PLANNING TECHNICAL REVIEW COMMITTEE –AGENDA

Re: Dover Heights (P-19-15)
Redevelopment of 1 First Street, Dover, NH
Technical Review Committee Minutes, Site Plan Review, March 7, 2019
KNA Project No. 17-1219-1

RESIDENTIAL SITE PLAN

DOVER HEIGHTS

UTILITY PLAN
DOVER HEIGHTS
MAP 6 LOT 20
1 FIRST STREET
DOVER, NEW HAMPSHIRE
STRAFFORD COUNTY
PLANNING FILE # P19-16

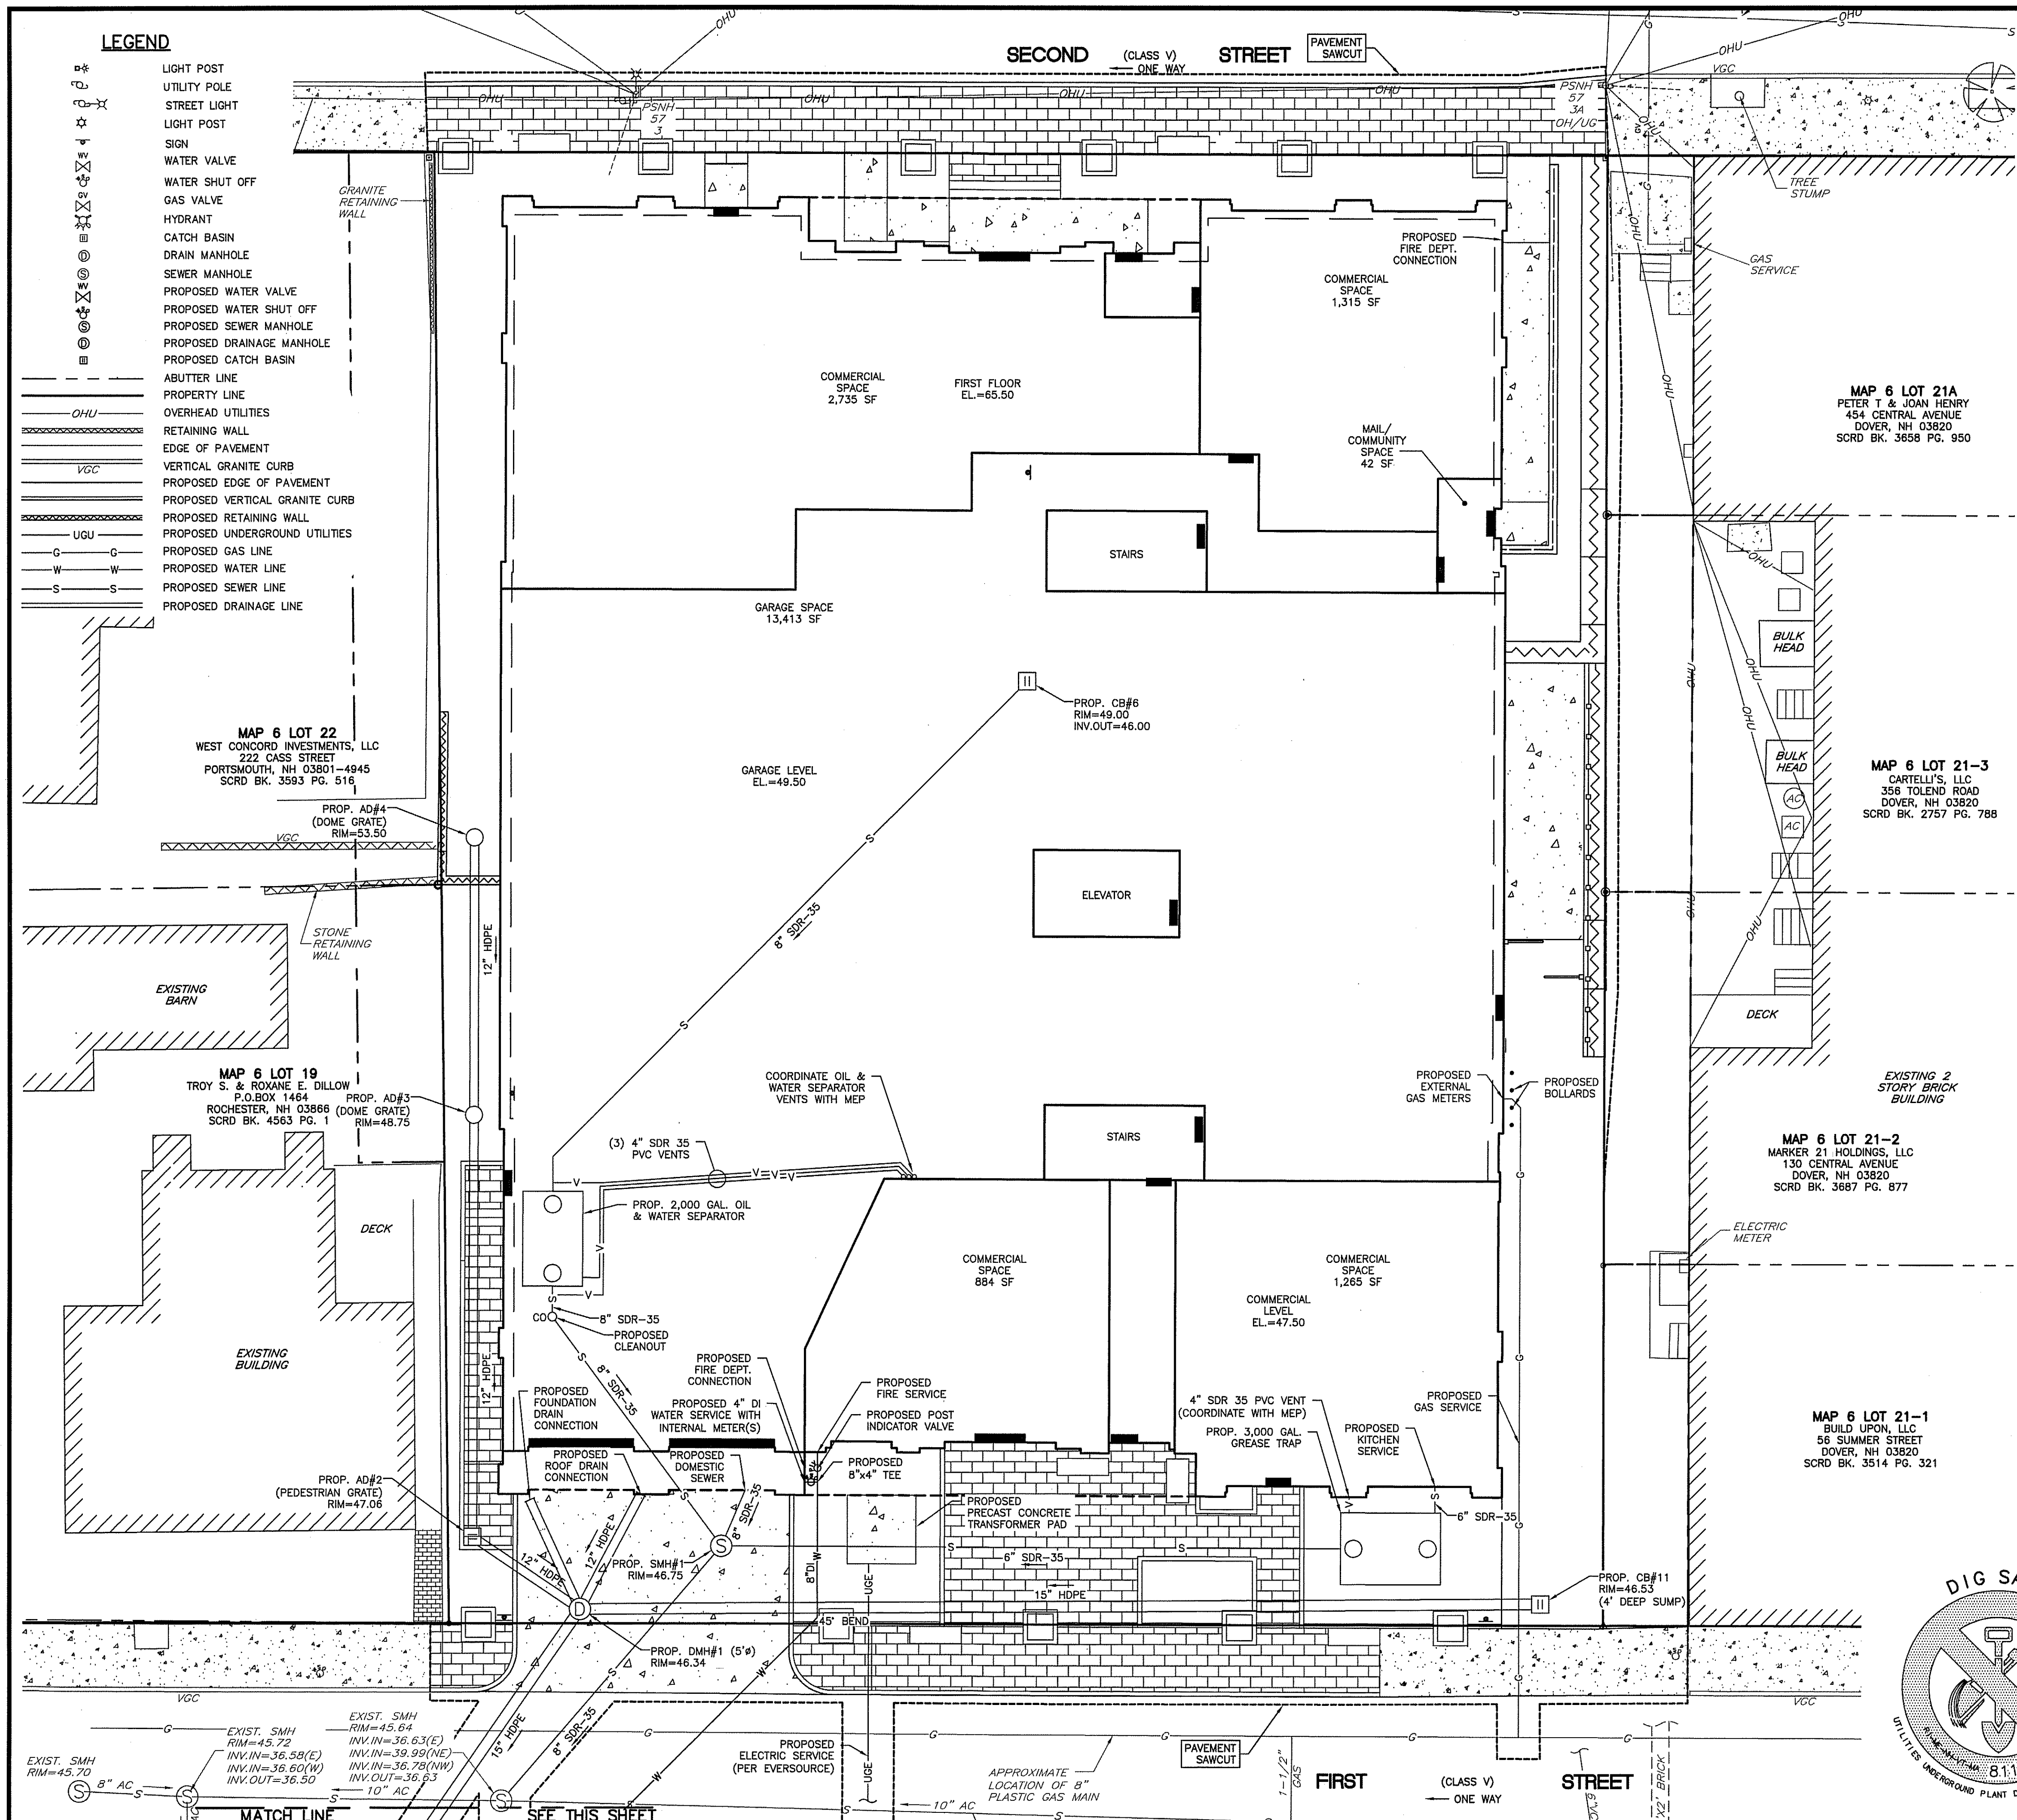
2. Water and Sewer Investment fees

6. Plan sheet 7, FDCs may be required on each street at the front.

Fee calculation has been included on Utility Plan, Sheet 7.

Water meters are noted as internal and gas as external on Utility Plan (sheet 7).

Underground service will be provided across First St. per Eversource. Sheet 7 has been revised to reflect this.

A second FDC has been noted on the Second St. side of the building at the walk accessing the residential space (sheet 7).

SECOND STREET ELEVATION
1/8" = 1'-0"

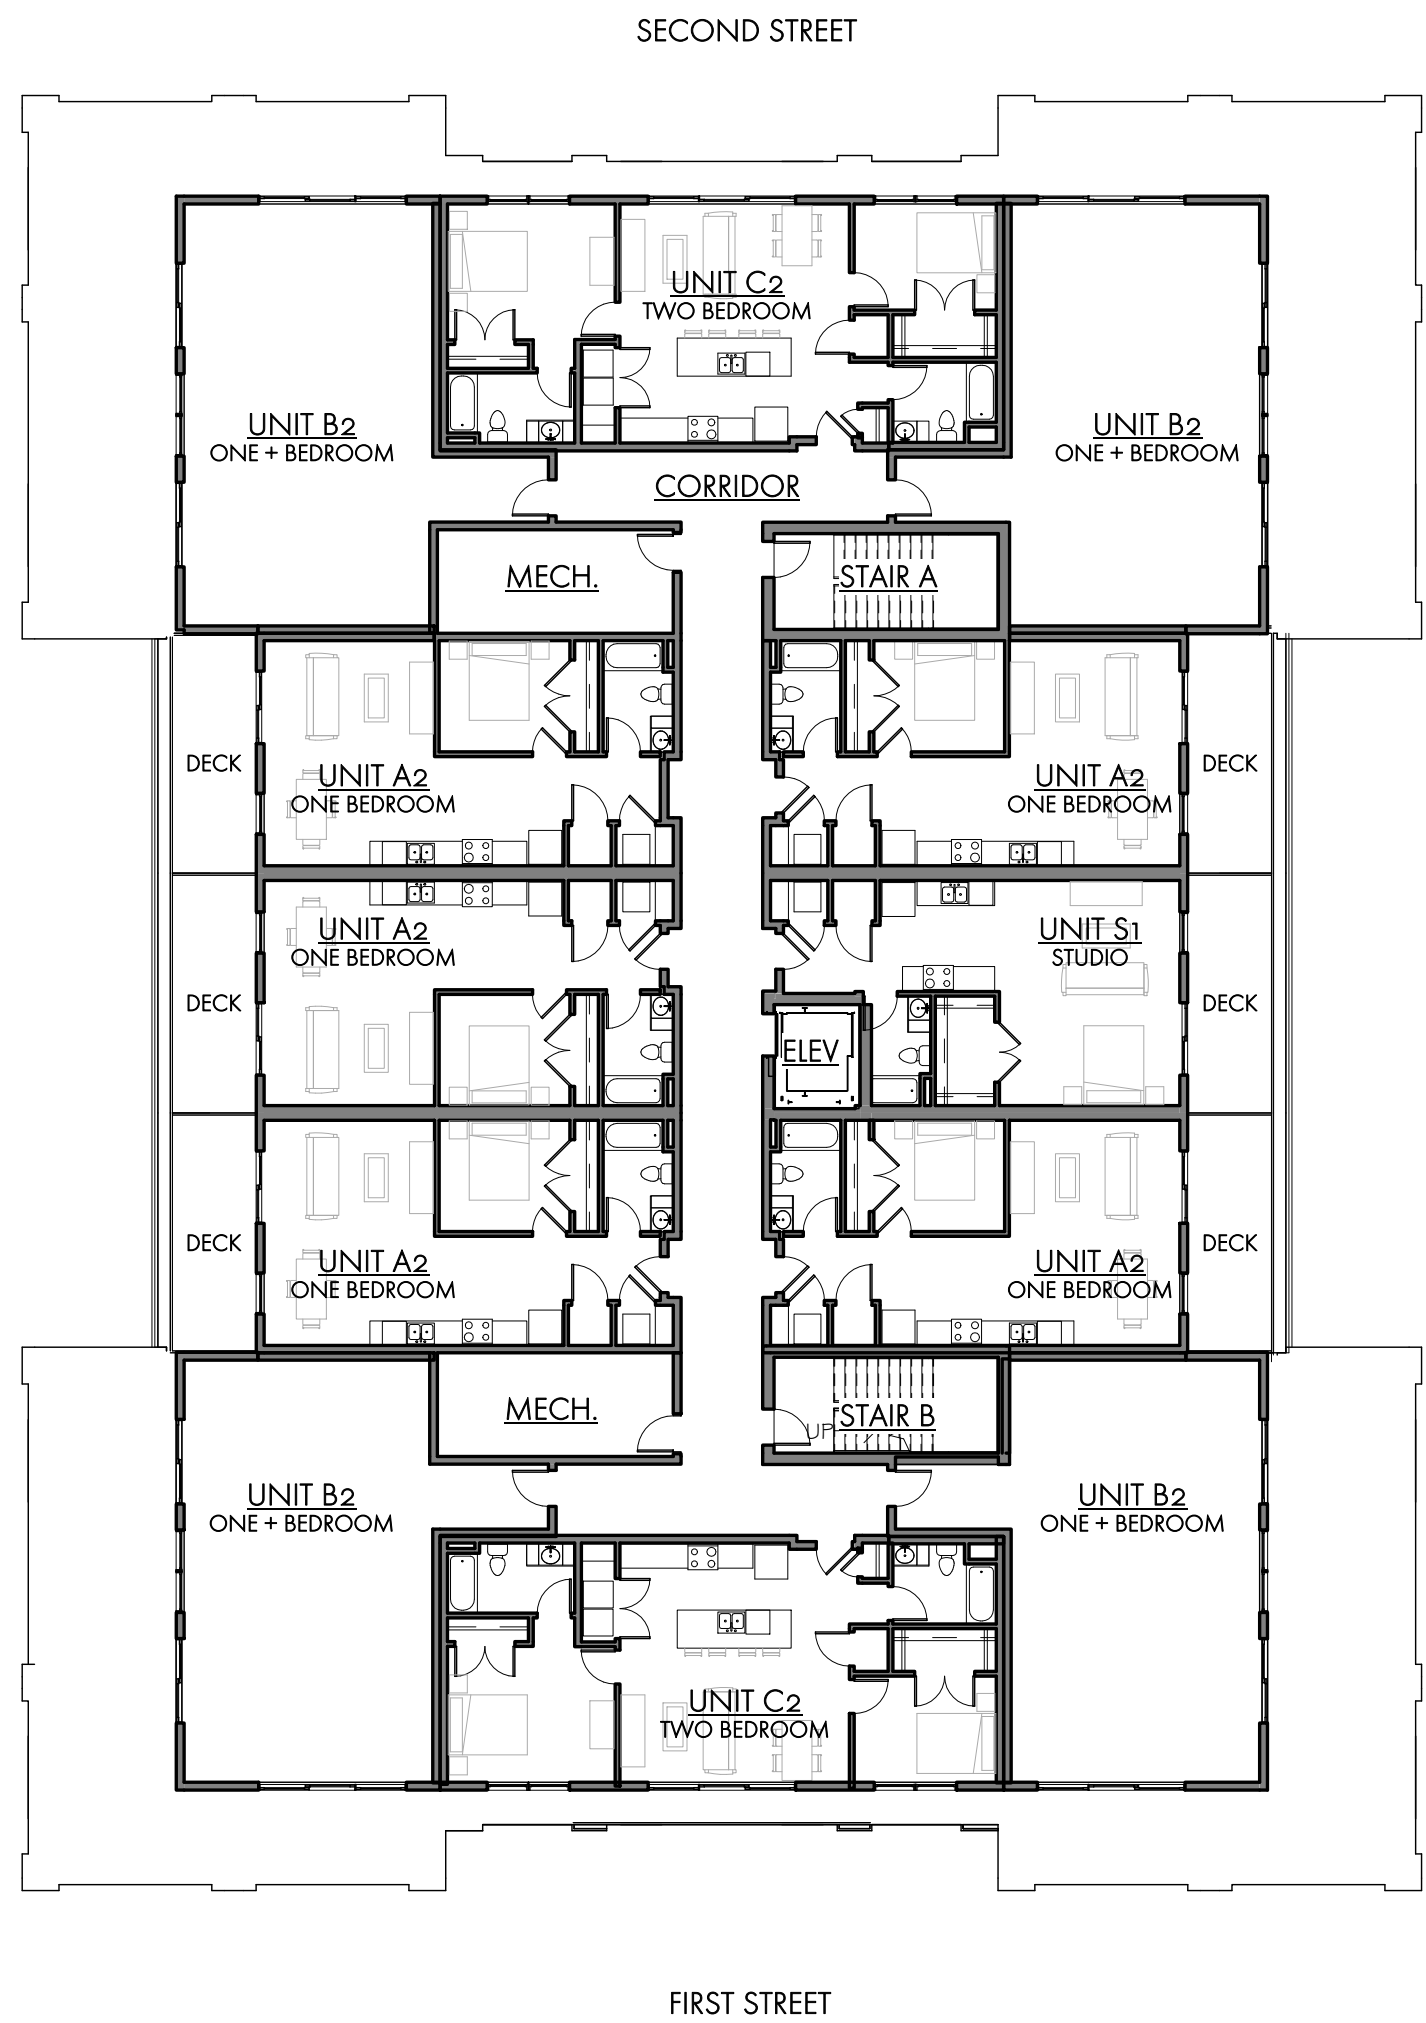
- c. Building materials on elevations for all sides of all buildings.

11. Indicate the type of siding for the first and second story.

The architectural elevations were revised to indicate materials

The architectural elevations were revised to indicate siding materials.
